# UNITED STATES PATENT AND TRADEMARK OFFICE

APPLICATION NO.	FILING DATE	FIRST NAMED INVENTOR	ATTORNEY DOCKET NO.	CONFIRMATION NO.
10/702,198	11/04/2003	Victor Lee Walker	08168-053001	7120
20985	7590	07/07/2005	EXAMINER	
FISH & RICHARDSON, PC 12390 EL CAMINO REAL SAN DIEGO, CA 92130-2081			MITCHELL, KATHERINE W	
			ART UNIT	PAPER NUMBER
			3677

<b>Office Action Summary</b>	Application No.	Applicant(s)	
	10/702,198	WALKER ET AL.	
	Examiner	Art Unit	
	Katherine W. Mitchell	3677

**DETAILED ACTION**

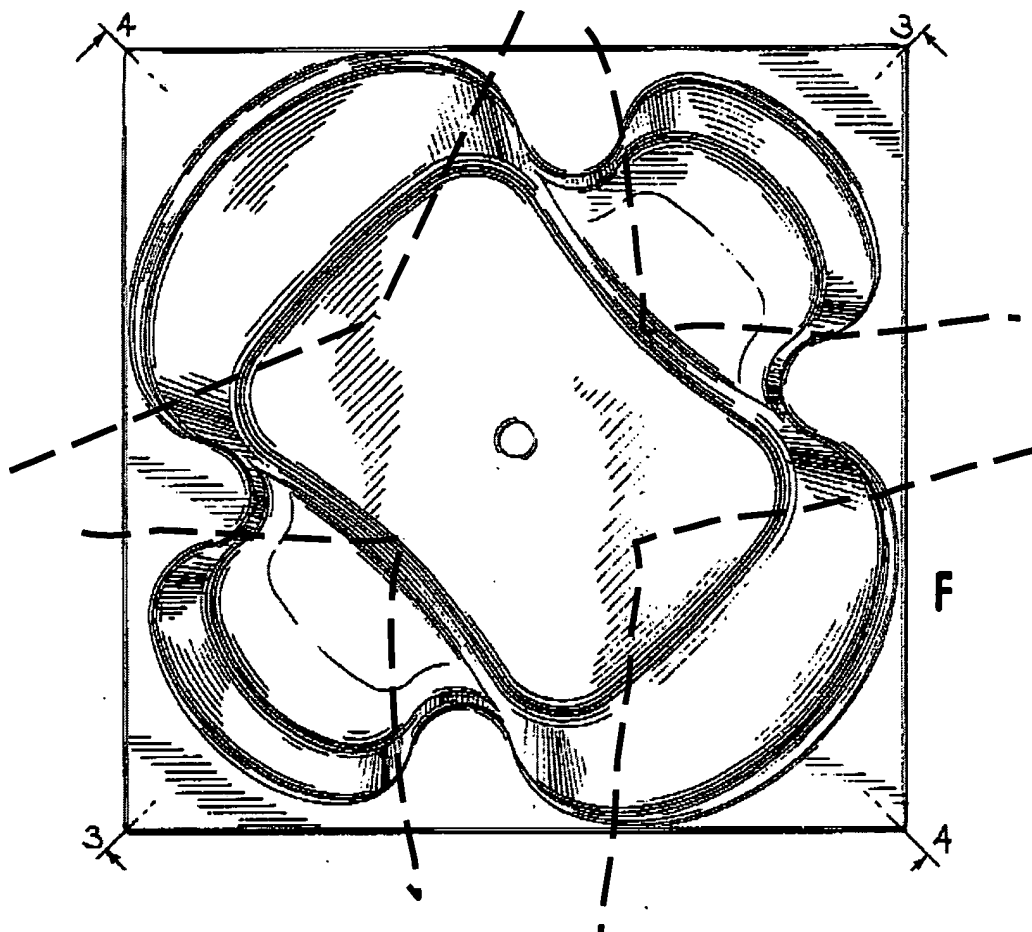
Re claim 13: Kohler teaches a curvilinear spa shell comprising:

- a top edge defining an interior of the spa shell, the edge having 4 rounded concave relative to the interior corners (see marked up Fig 2 below—4 corners are marked off by examiner in dashed lines) each corner having a radius that exceeds 12 inches (inherent, as the smaller opposed corners clearly are formed as seats, and a drain is also shown to give proportions clearly in excess of 12" radius for each curved corner) and
- four curved side walls that are convex relative to the interior, each wall connected between two of the concave corners (between areas marked off as dashed lines by examiner)
- Wherein the top edge is substantially symmetrical both about an axis that bisect the interior through two side walls (inherent in the figure shown) and
- substantially symmetrical about an axis that bisects the interior through two corners (inherent in the figure shown).

Re claim 14: The drainhole shown is considered a water feature, as water drains through it.

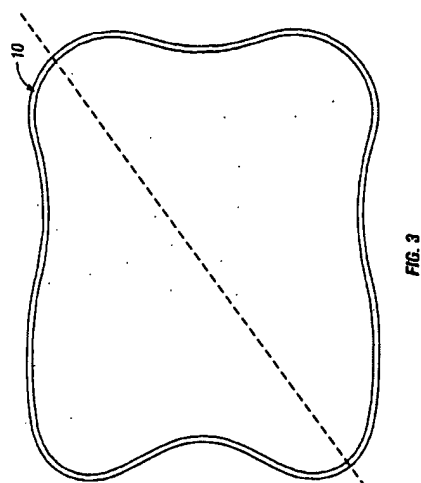
7. Applicant's arguments filed 5/19/2005 with respect to Kohler have been fully considered but they are not persuasive:

Examiner notes that applicant has claimed "**substantially** symmetrical".

Examiner considers Kohler's halves formed about the axis bisecting the interior through two side walls to be "substantially symmetric" (perfectly symmetrical halves are inverted with respect to each other), and considers Kohler's halves formed about the axis bisecting the interior through corners to be perfectly symmetric.

Note that applicant's invention is not perfectly symmetrical about an axis that bisects the interior through two corners, (dotted line added by examiner), which forms perfectly symmetrical halves that are inverted, in the exact same manner as Kohler is substantially symmetrical about an axis that bisects the interior through two side walls.
